SUBJECT: Subcontract S005242-F  
**REVISION 1 TO** Request for Deviation (RFD) Number 14-009

<i>NCSX RFD</i> <i>Part I</i>	Number: 14-009 Rev 1	RFD Description: Deviations on C1 Casting that are Applicable to Downstream Castings
Initiator: Phil Heitzenroeder		Organization: PPPL
List of Impacted Documents: ( <i>Specification, MIT/QA Plan, SOW, drawing, etc.</i> ): CSPEC (NCSX-CSPEC-141-03) and drawings SE141-103 (Item 1), SE141-078 (Item 2), DS11-036 (Item 3), and SE141-116 (Items 4-9).		
Cost Impact: ( <i>If none, so state</i> ): TBD, but C2 casting changes anticipated to be <\$2K. EIO/MTM to provide more detailed estimate within 30 days of receipt of this RFD.		
Schedule Impact: ( <i>If none, so state</i> ): TBD, but C2 casting changes not anticipated to result in a delay. EIO/MTM to provide more detailed estimate within 30 days of receipt of this RFD.		
Quality Impact: ( <i>If none, so state</i> ): NONE		
State Requirement Deviation is Requested For: ( <i>Specification, MIT/QA Plan, SOW, drawing, etc.</i> ): CSPEC will be updated (Rev 10 in process) and will incorporate drawings and models that include these changes.

The following drawing changes are proposed:

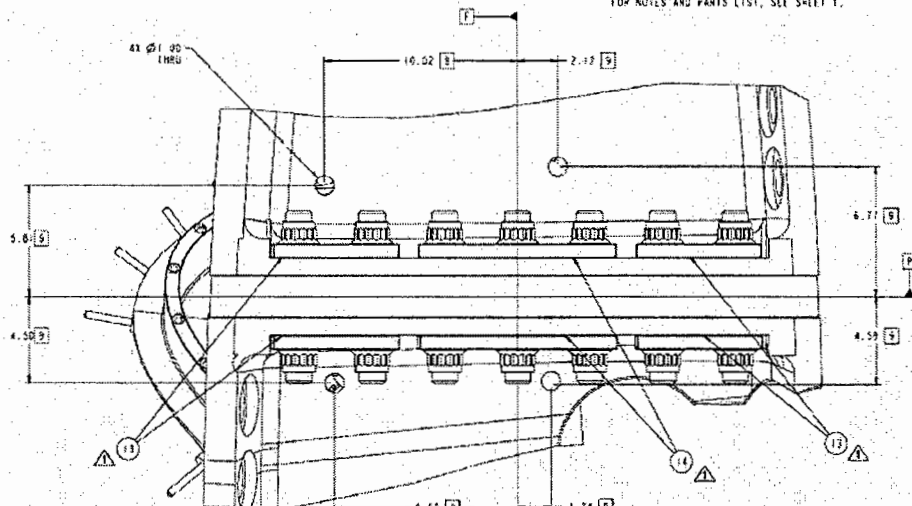
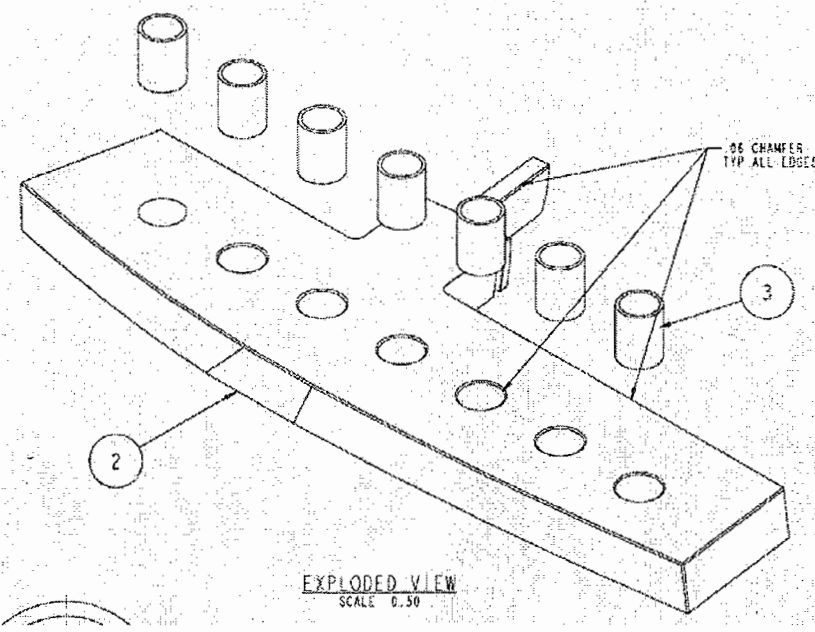
Item	Drawing	Sheet	Zone	Issue	Resolution
1	SE141-103	1 2	C2 D5	Washer not suitable for thin flange, required bolt preload.	Replace washer with bearing plates, SE141-137 and SE141-138.
<p style="text-align: right;">FOR NOTES AND PARTS LIST, SEE SHEET 1.</p>  <p>The drawing shows a cross-sectional view of a component assembly. It features a central horizontal shaft with several bolts. Dimensions include 41 Ø 1.92 THRU, 16.52, 2.12, 5.0, 4.58, 6.77, 4.59, 6.50, and 1.74. Callouts 13, 14, and 15 are present. A note at the top right reads 'FOR NOTES AND PARTS LIST, SEE SHEET 1.'</p>					
2	SE141-078	1	F7	Shim edges are flush with insulator, making it difficult to seal for VPI. Also, potential for voltage breakdown.	Add instruction to chamfer all shim edges 1/16".
 <p>The drawing is an exploded view of a shim. It shows a rectangular shim with several circular holes. A chamfered edge is highlighted with a callout '3'. A note indicates 'Ø6 CHAMFER TYP ALL EDGES'. A callout '2' points to the shim. The text 'EXPLODED VIEW' and 'SCALE 0.50' is located at the bottom center.</p>

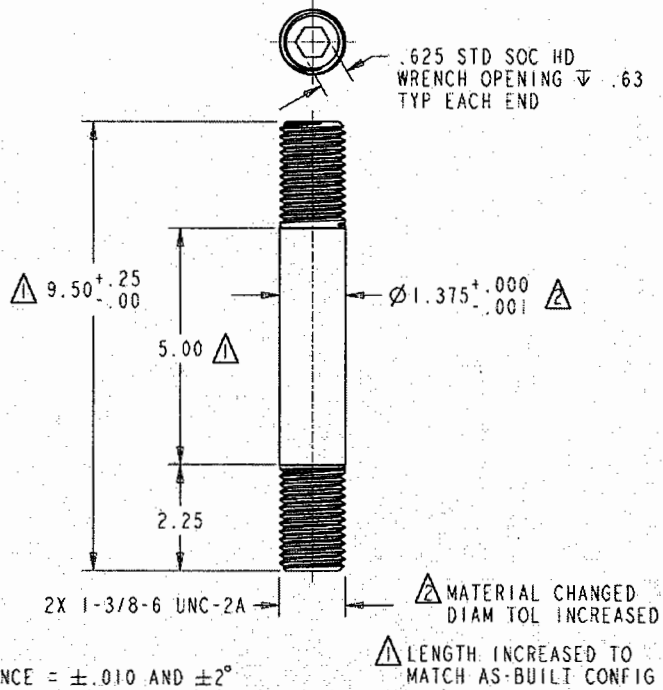
Item	Drawing	Sheet	Zone	Issue	Resolution
3	DS141-036 (stud)	1	N/A	Material specification is incorrect (both drvs) and stud length must match revised drawing to accommodate bearing plates.	Revise material to ASTM A453, Grade 660B.
	DS141-060 (nut)	1	N/A		(INFO REVISED 10/24/2005)

MATERIAL	UNS S66286	SOURCE	BID / PREFERRED
SPEC	ASTM A453 GRADE 660B	VENDOR

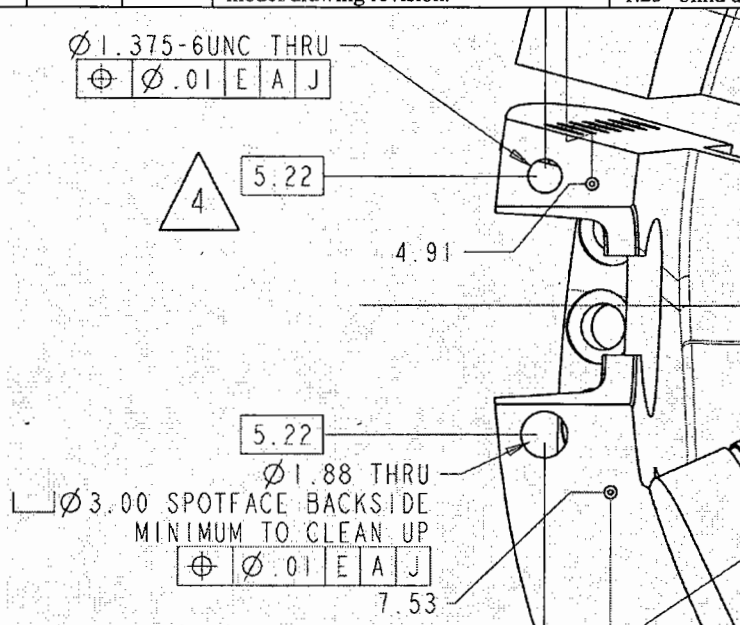
4	SE141-116	5	E8	Tapped and thru hole were not positioned according to latest model/drawing revision.	Adopt latest rev for hole position, change tapped hole from thru to 1.25" blind due to flange radius.
---	-----------	---	----	--	---

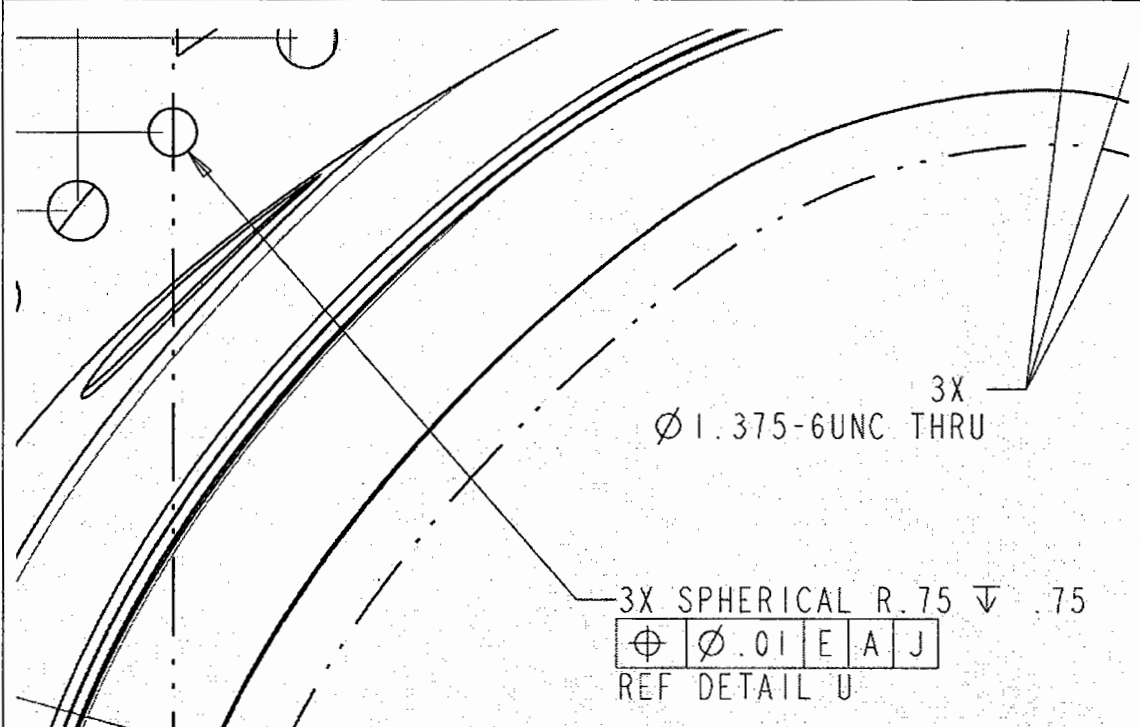
Item	Drawing	Sheet	Zone	Issue	Resolution
5	SE141-116	5	F7	Spherical seat size tolerance +/- .01 is not suitable for intended use.	Change size tolerance to +.002/-.003. Pilot hole up to 3/8" is acceptable. Lap finish to final size tolerance of +.002/-.000.

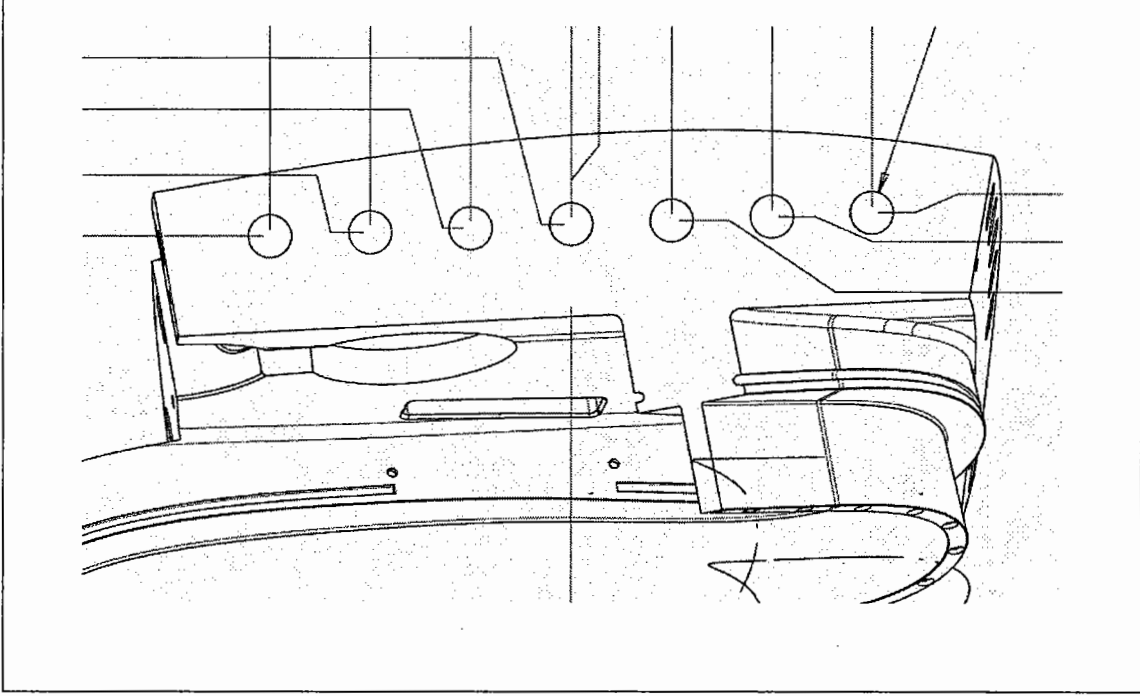
6	SE141-116	6	D3	Poloidal break edge is flush with insulator.	Add instruction for 1/16 chamfer all surfaces and edges of break.
---	-----------	---	----	--	---

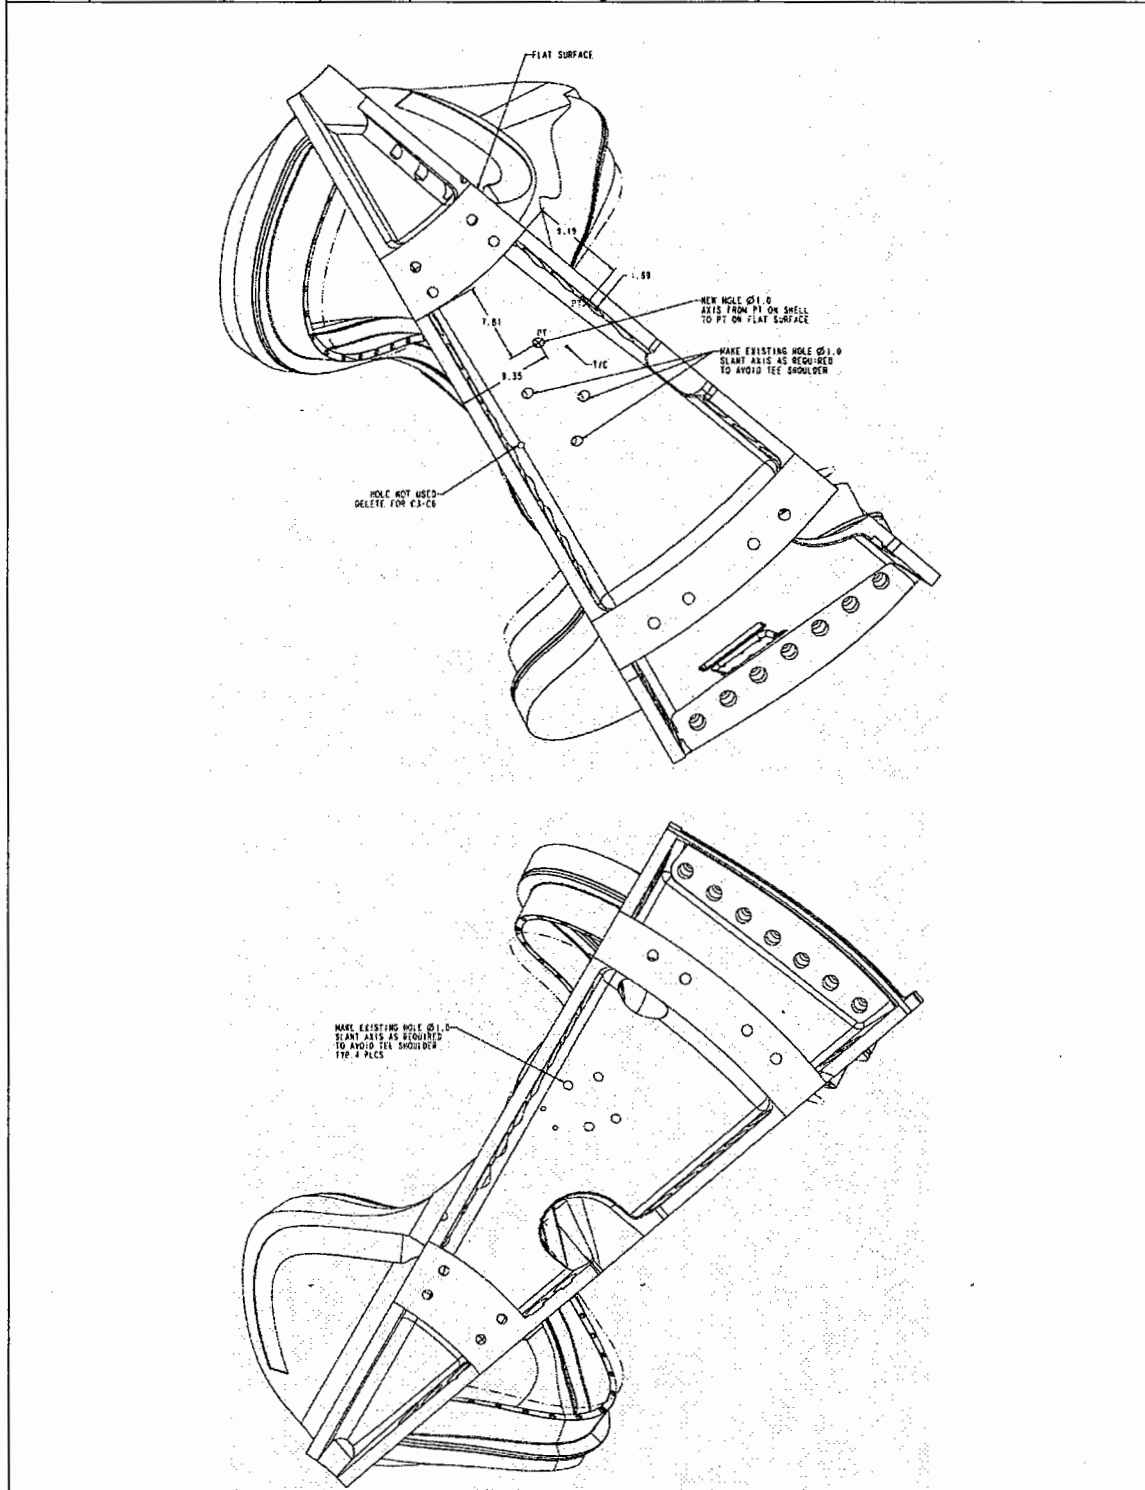
Item	Drawing	Sheet	Zone	Issue	Resolution
7	SE141-116	9	C7 F3	Cooling inlet/outlet thru hole diameter is too small, and one hole interferes with flange.	Revise location and diameter of the interfering hole and the diameter of the other seven holes.

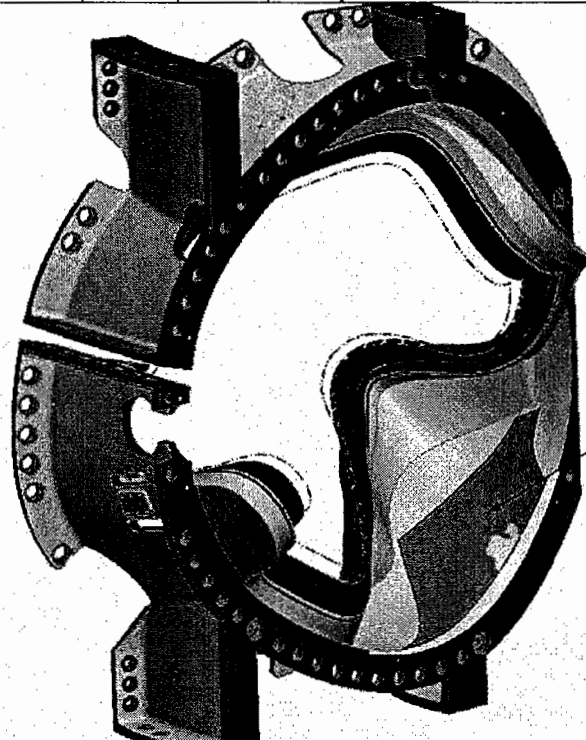
Item	Drawing	Sheet	Zone	Issue	Resolution
8	SE141-116	10	D2	As-cast tolerance is not suitable over a small area where wing of adjacent coil overlaps.	Revise profile tolerance to +0 / -.1 over area defined by IGES surface.

MACHINE / GRIND THIS AREA TO PROFILE TOLERANCE OF +0/ -.1

**Attachment 2  
IGES View of Holes**

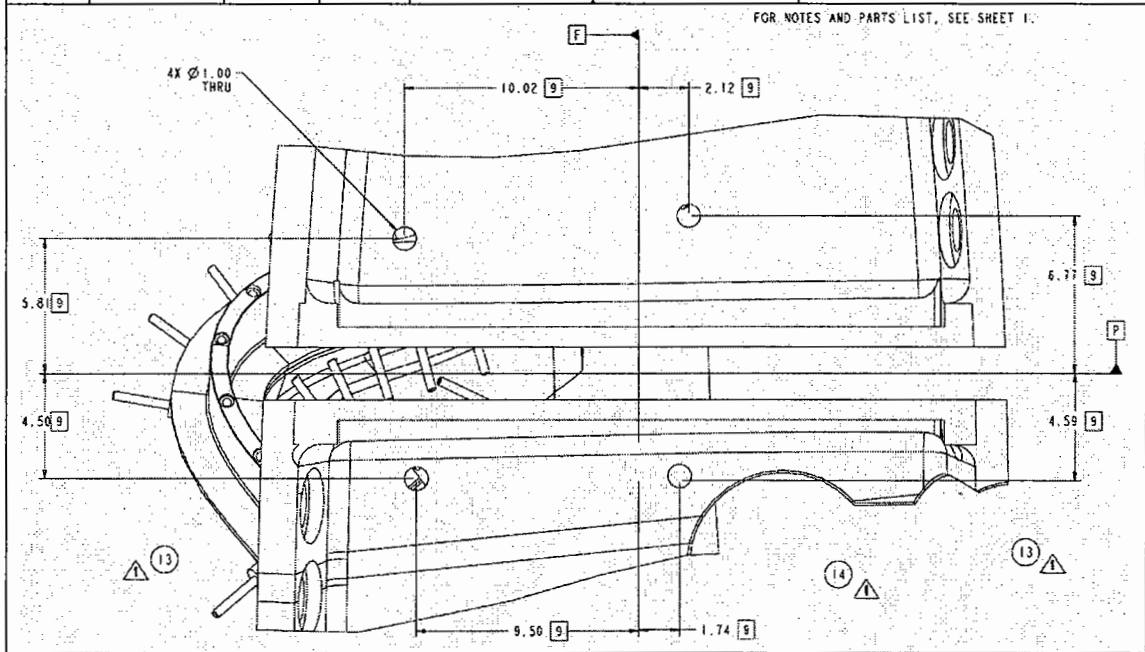
9	SE141-116	NEW	N/A	Four thru holes to be added for cooling line inlet/outlet at poloidal break.	Add drawing view.
---	-----------	-----	-----	--	-------------------
